Dane County Rezone Petition

Application Date	Petition Number
10/24/2022	DCPREZ-2022-11913
Public Hearing Date	
12/13/2022

CREATE A 2.8-ACRE COMMERCIAL LOT FOR A MATERIAL STORAGE BUSINESS

Sunset Hideaway Acres – 1161 Hwy 14 – Revised 11/14/2022

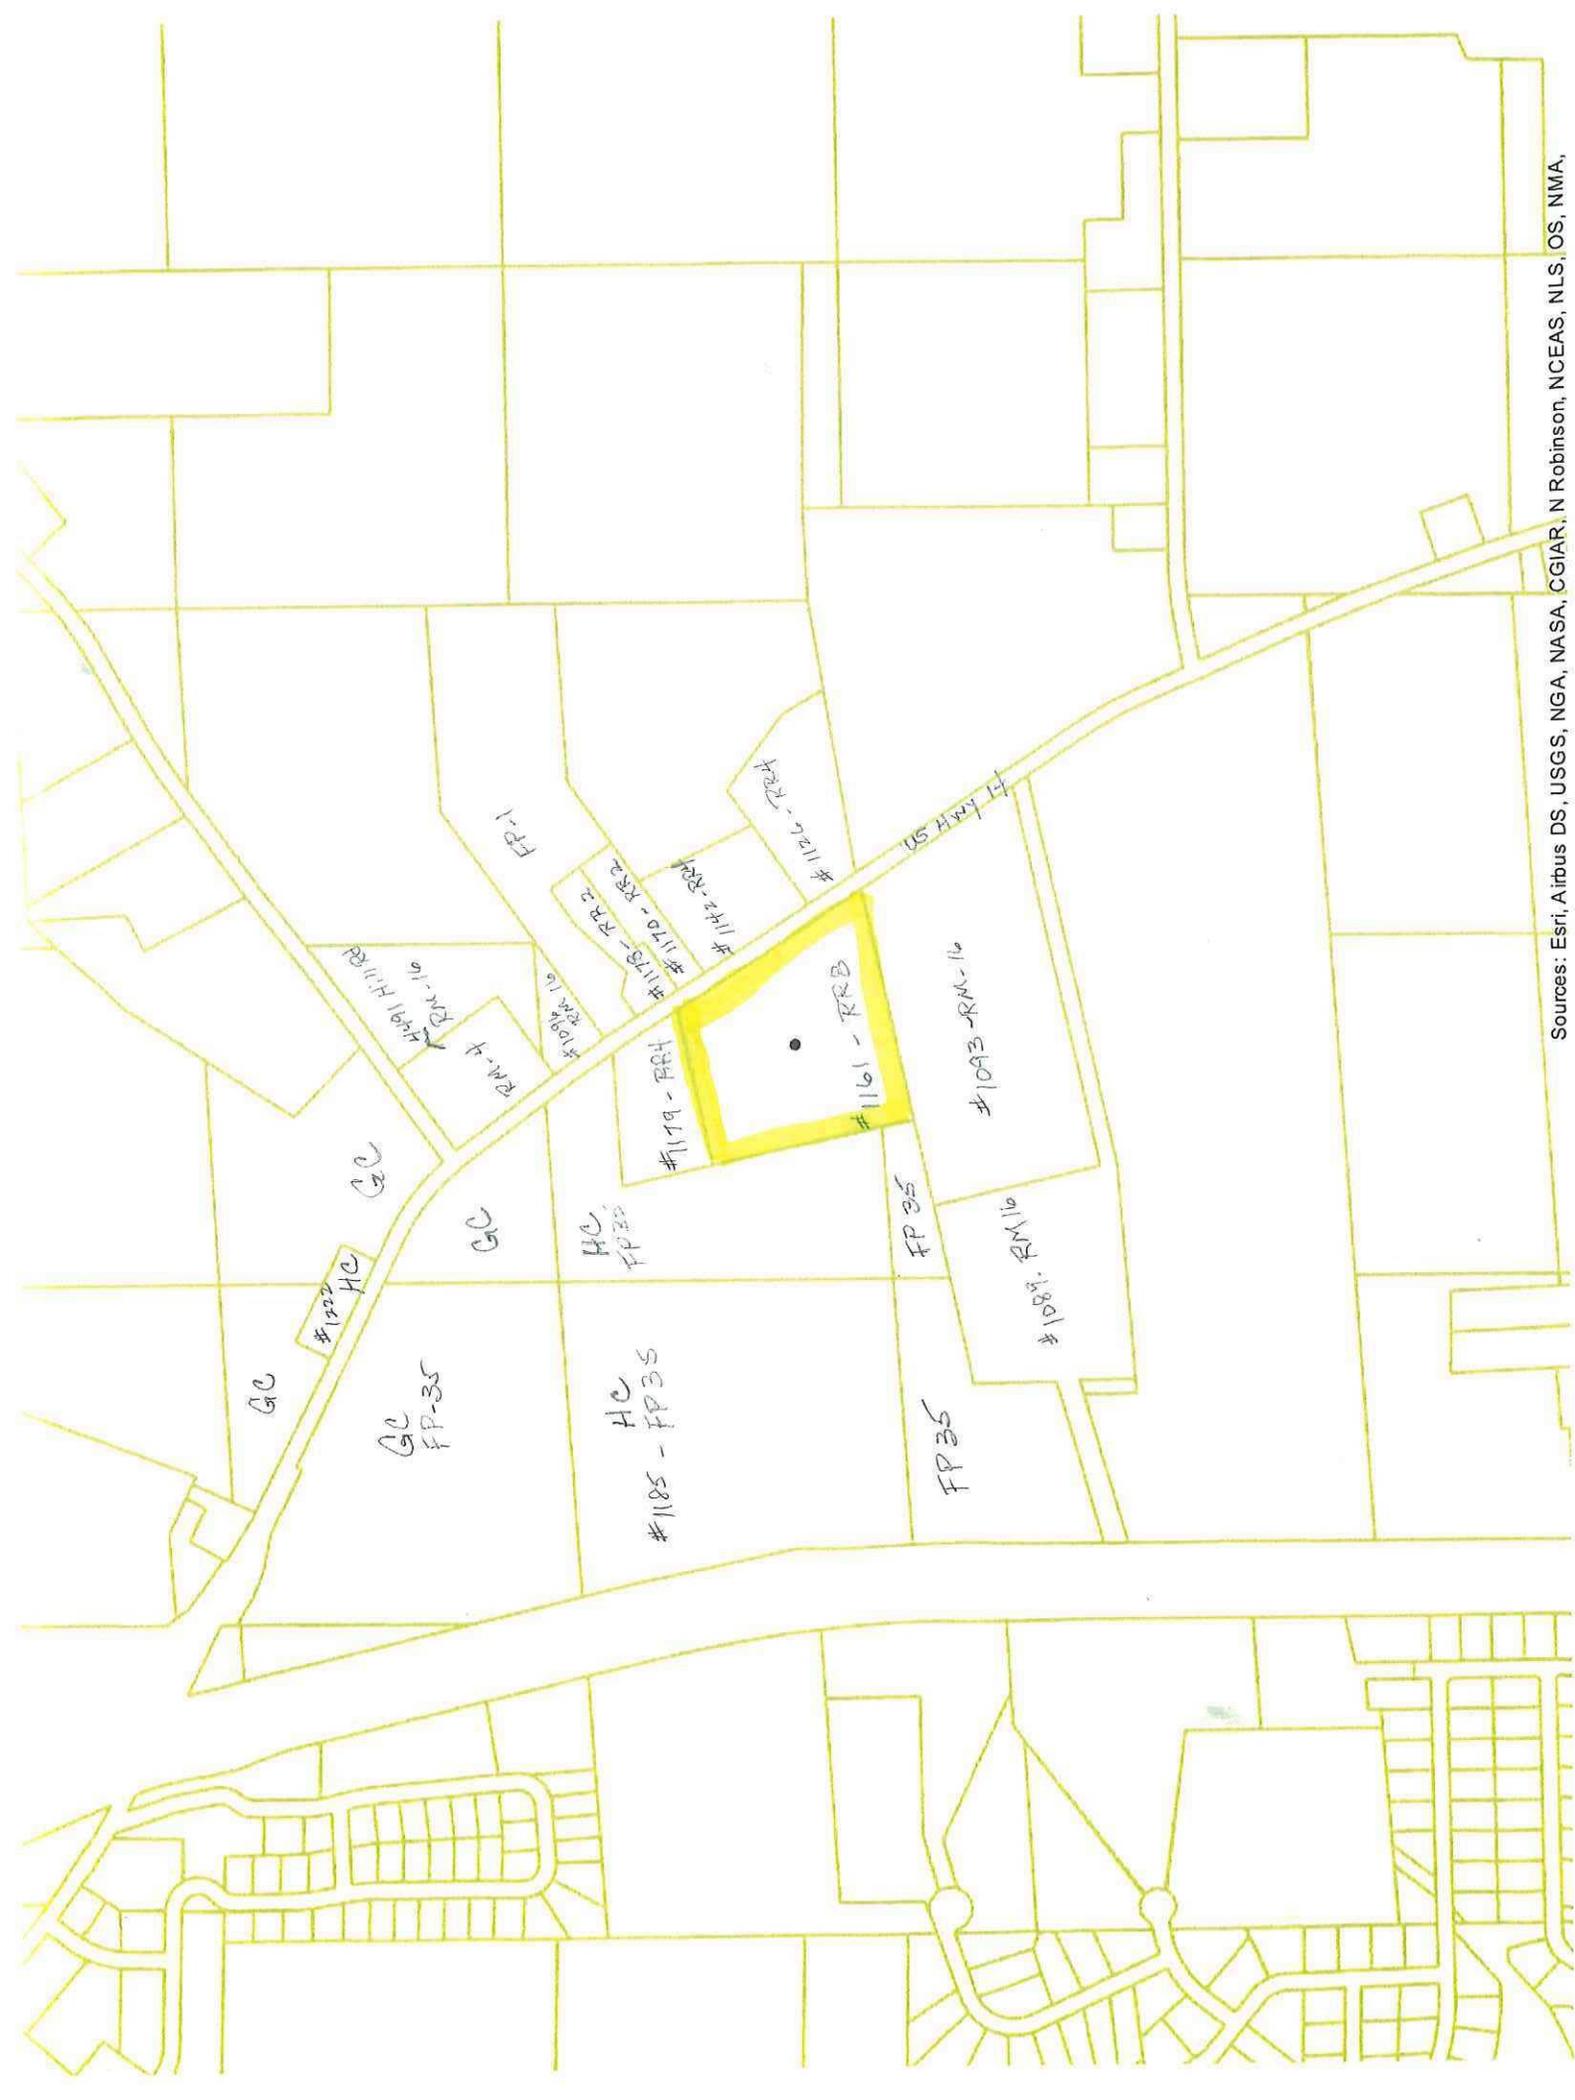
- 4) Proposed Usage document states "Lighting is currently positioned on existing buildings and on existing light pole and is downward facing, dusk-to-dawn solar lighting. Additional downward facing lighting for Outside Storage area will be added as needed on the back side of the Pole Building" and "The solar lighting is effective, yet subdued to mitigate any light impact to neighbors or traffic passing by."
Current lighting is: two on front of 40x80 pole building, one on front of 30x30 garage building, one on front of small pump house, one on existing light pole. So there are 5 existing. I have marked these with yellow highlighter on the

site plan mark up, attached. As for proposed lighting as needed, I have marked two on the back of the 40x80 building as our best estimate right now.

I am attaching the site plan marked up with lighting - you should see 5 existing and 2 proposed = total of 7 yellow highlighted marks. I may not have a chance to pull pictures from my office yet today so will plan to send those for you to have first thing Monday morning. PLEASE feel free to reach out to me via phone or text at 608-445-8747 at ANY TIME so we can meet the deadline for Dec 13th. Thank you so much Rachel!

3. Fencing details – Narrative describes 5-6' high with gates and lighting. What type of material? Can you share an example picture?
4. Lighting – Narrative describes existing and proposed lighting. Please send photos of the existing fixtures. And also show on the site plan the locations of all existing & proposed light fixtures (can be just a markup of the Burse plan). This will address both zoning requirements, and the Town land use policy to “Ensure that new outdoor lighting is designed to limit glare and light trespass.”

5. Please show dumpster location on site plan, if you will have one (could just be marked up).
6. The landscaping description is very general. Did the town provide any guidance or comment on their expectations for that? The zoning code does not seem to require specific landscaping or screening requirements in this case, based on the distance from the commercial area to nearby homes.
